**SAFETY EVALUATION BY
THE OFFICE OF NUCLEAR REACTOR REGULATION
RELATED TO NRC GENERIC LETTER 2004-02,
NUCLEAR ENERGY INSTITUTE
GUIDANCE REPORT
(PROPOSED DOCUMENT NUMBER NEI 04-07),
“PRESSURIZED WATER REACTOR
SUMP PERFORMANCE EVALUATION METHODOLOGY”**

The Nuclear Energy Institute (NEI) submitted (proposed document number NEI 04-07) "Pressurized Water Reactor Sump Performance Evaluation Methodology" (NEI, 2004a, referred to herein as the Guidance Report or GR), for review by the U.S. Nuclear Regulatory Commission (NRC, the staff). NRC approval of this methodology guidance would allow licensees of pressurized water reactors (PWRs) to use the document in their responses to recently-issued NRC Generic Letter 2004-02, "Potential Impact of Debris Blockage on Emergency Recirculation During Design Basis Accidents at Pressurized-Water Reactors" (GL-04-02), as the cited NRC approved methodology for their evaluation of plant-specific sump performance. The Generic Letter identifies inadequacies in previous approaches for modeling sump screen debris blockage and related effects, such that the staff no longer considers many licensing-basis analyses acceptable for confirming compliance with NRC

Figure 3-1. Comparison of GR Isobar Map with Isobars from Independently Evaluated ANSI Jet Model

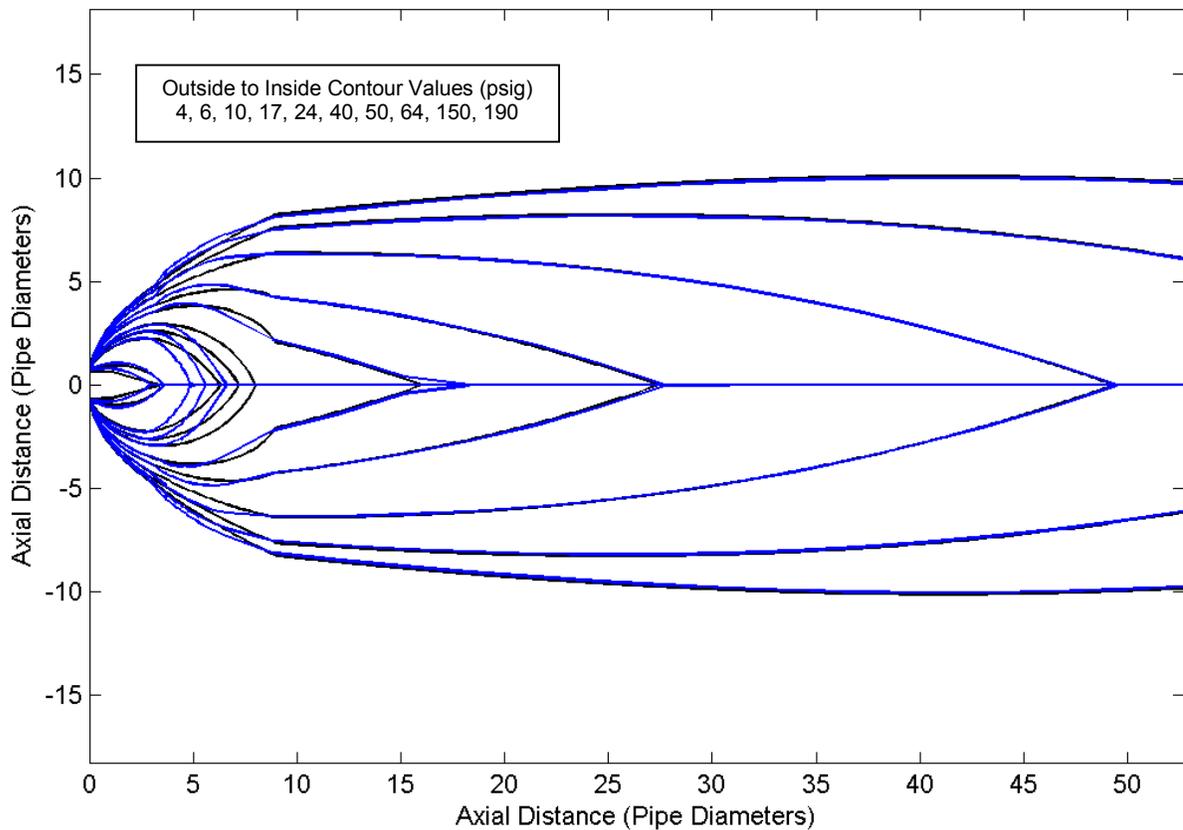
In order to confirm that the ANSI jet model was implemented properly the model was independently programmed and the results compared with the isobar map tabulated in Table D-1 of the GR. This comparison is shown in Fig. 3-1 where the blue contour lines represent the GR evaluation of a break at 2250 psia and 540 °F and the black contour lines represent a reference cold-leg break at 2250 psia and 530 °F. See Appendix I of this SER for an explanation of the independent calculation and additional guidance on interpreting results of the ANSI jet model.

Good agreement is seen between the calculations for downrange behavior (Zone 3), but discrepancies exist in Zones 1 and 2. It appears that contour termination points on the centerline are not accurate and that the quadratic behavior of the Zone 2 isobar equations is not implemented correctly. These differences will have a negligible effect on volume integrals for jet pressures less than 20 psig, but may become more of a concern for higher pressures near the break. To quantify the magnitude of the difference, Table 3-1 below presents a comparison of ZOI radii computed from both methods. In particular, the GR approach may not have preserved the system stagnation pressure throughout the volume of the liquid core region as specified by the standard. However, the GR recommended values essentially bound both sets of calculated values.
